Letter No. 384
BY-CRE-05031

Project: I-405/Brickyard to SR 527 – Improvement Project
Contract No.: 009727

Subject: Notice of Protest 019 – Supplemental - Issue SKA-0303 – Juanita Creek Lateral Migration

Project: I-405, Brickyard to SR 527 Improvement Project
Contract No: 009727
RE: Notice of Protest: PCN-00153 – Juanita Creek Lateral Migration

Figure 8.1.10-1 Scour without Lateral Migration

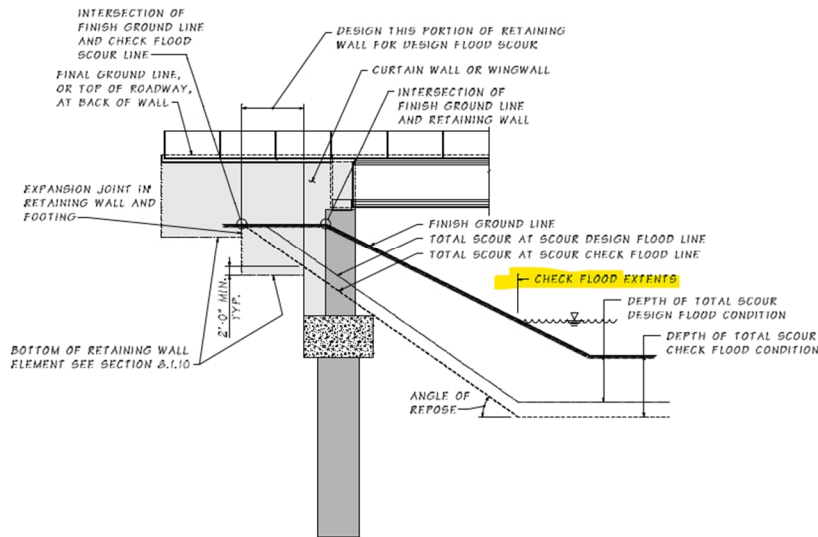
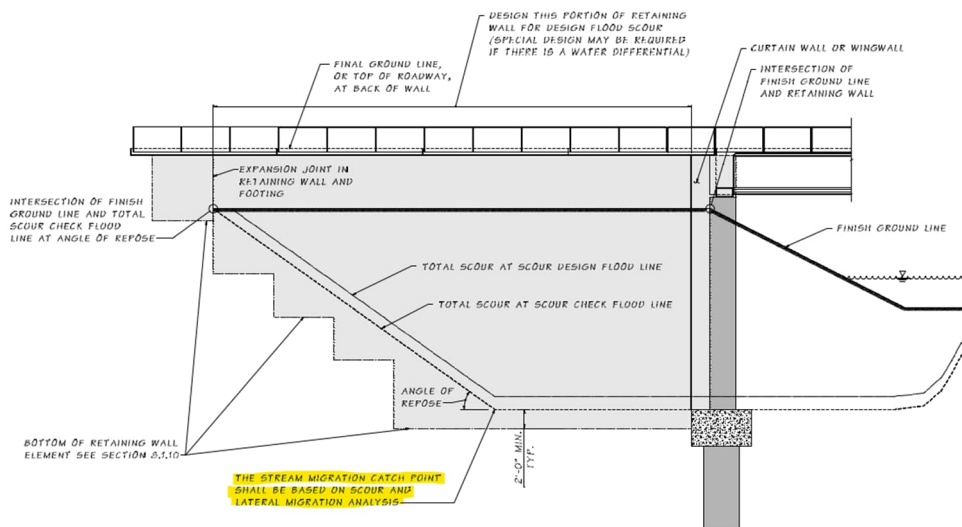
Despite the Contract's clear designation, WSDOT issued RCSR comments that directed the Design-Builder to incorporate lateral migration analysis. The structural comments on the East Portal (Comments 3 and 4, HQH) used mandatory language:

- **Comment 3 (HQH):** "See BDM 8.1.10 Scour of Retaining Walls... Please confirm bottom of wall is 2 feet below total scour at check flood elevation; **including lateral migration (structural).**"
- **Comment 4 (HQH):** "The foundation for all walls constructed along rivers and streams **shall** be evaluated during design... Also see **Figure 8.1.10-2**" (the figure WITH lateral migration).

The incorporation of lateral migration at WSDOT's direction resulted in the use of BDM Figure 8.1.10-2 (Scour WITH Lateral Migration) rather than Figure 8.1.10-1 (Scour without Lateral Migration). This impacted:

9. On June 28, 2025, WSDOT, in an apparent reversal, closed all RCSR comments related to lateral migration. AECOM subsequently selected BDM Figure 8.1.10-1 to estimate a scour prism in order to provide a scour countermeasure. This utilizes the 500-year extent and arrives at a width of approximately 38 feet. It should be noted this was AECOM’s original plan, meets Contract requirements, and includes scour countermeasures in the design.

Juanita scour prism at MSE wall:

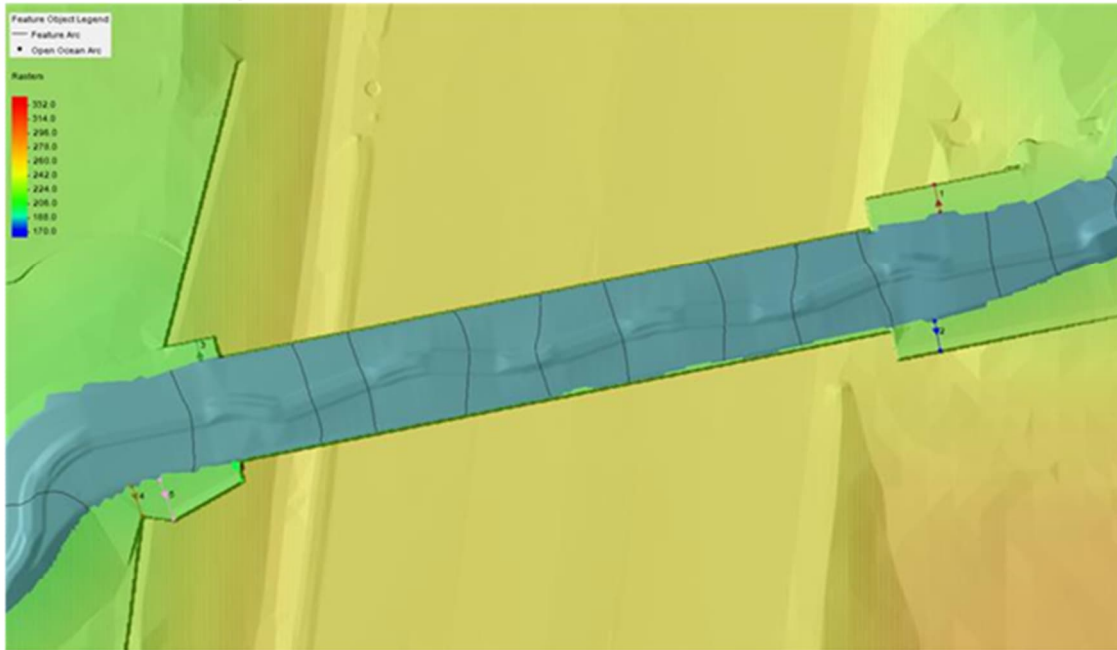
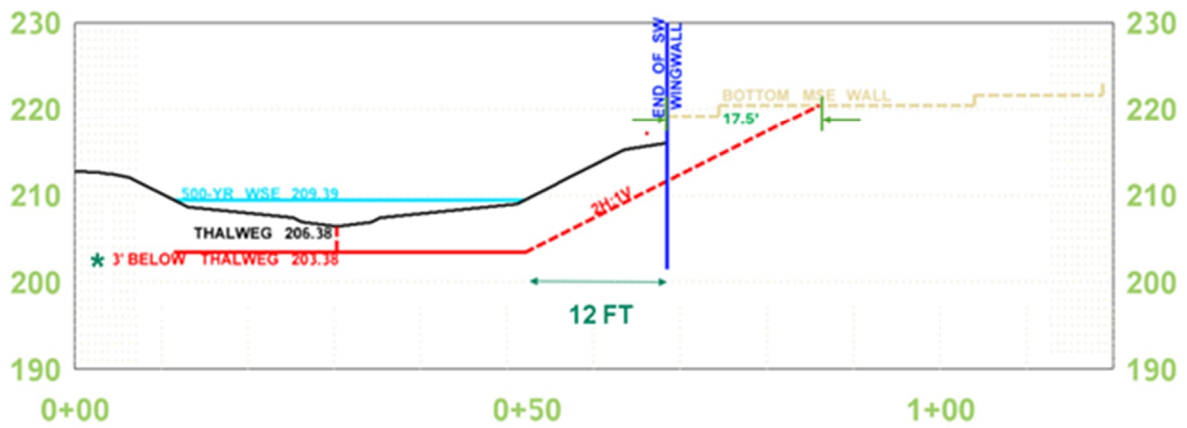
We look forward to speaking with you soon. In case you had a little bit of time before the call, we wanted to send along some bullet points we would like to discuss. In response to a structural comment from Jason Pang related to protection of the downstream MSE at Juanita Creek, we need to quantify potential extent of lateral migration. Up until now, we have found it difficult to develop an exact value for lateral migration, and thus, designed tunnel and wingwalls for full scour depth:

- We propose that the modeled **500yr extents be considered the extent of lateral migration**.

I have similar comments/concerns. One of my added comments is to understand where/how the 30' meander width was estimated; and why the tunnel was additionally widened.

I didn't see any validation to the meander width or valley width in the updated FHD to support the outer limits of what the historic migration limits would be.

Depending on where the walls are located; I believe you could use a countermeasure to mitigate total scour but I have to double check which manual that is in.

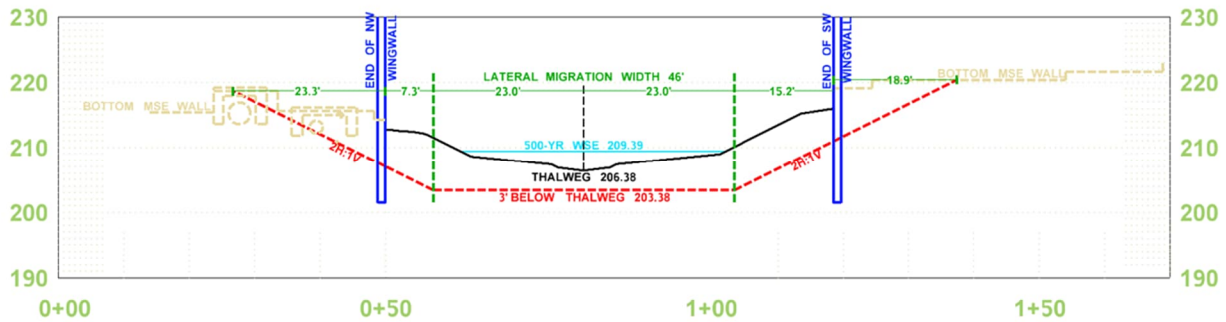
We would like to come to a consensus on lateral migration extents for Juanita Creek as soon as possible, since this impacts other disciplines. We performed an updated valley width analysis for Juanita Creek, something we discussed with Gabe several months ago (Alex, I don't think you were on that call). We looked at cross sections in the design reference reach and estimated a conservative average width of **46.0 feet**. We propose to use this value for lateral migration extents. This is wider than the 30-foot meander belt width estimated by WSDOT for preliminary design, wider than the proposed tunnel width (37.8 feet), and wider than proposed 500-year extents downstream near the MSE wall.

To determine the lateral migration extents for Juanita Creek, valley width measurements were estimated for the design reference reach. Cross sections were cut for the nine upstream BFW locations (the most downstream BFW location was not used because it is near the bend in the creek where the valley floor widens in the wetland area). Valley width extents were estimated by analyzing grade breaks on the banks of the cross sections. They indicate the horizontal extent of the valley floor, which includes the river channel and associated floodplains and terraces. These are indicative of the extents that the channel could potentially migrate. The average valley width for the nine cross sections is 46.0 feet. This value will be used as a conservative estimate for the lateral migration extents. The figure below shows lines connecting the valley width extents for the 9 cross sections through the design reference reach. Appendix N [attached spreadsheet] shows the cross sections for each of these locations along with the valley widths.

- **6/18/2025** – Gabe Ng agrees with lateral migration extents and documentation, requests information to be included in the final FHD.
- **6/18/2025** – Yacoub Raheem responds by email with updated section view of the scour prism at the downstream end of the wingwalls (West Portal), to be used as a guide to design buried riprap following HEC-23 to protect the MSE wall. The width of the scour prism assumes 46 feet based on lateral migration analysis, as approved by WSDOT.

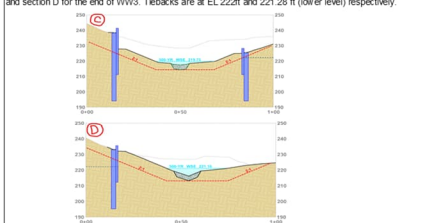
16	FP5-18	TB/JP	Z.28	At the end of wingwall 3 and 4, is the scour depth 10'-20ft as shown? Does that mean the anchors near the ends of the wingwalls will get exposed when scour occurs following angle of repose beyond the hydraulic width?	C	IR	The scour line has been reviewed by the hydraulic team and it extends above the ground anchors level for Wingwall 4, so no ground removal occurs under the ground anchor location. For Wingwall 3 the upper level tieback would be exposed. Further analyses noted that the tieback can be removed in the permanent condition, so it will only be working during the temporary stage. Refer to section below. C for the end of WW4 and section D for the end of WW3. Tiebacks are at EL 222ft and 221.25 ft (lower level) respectively.
----	--------	-------	------	--	---	----	---
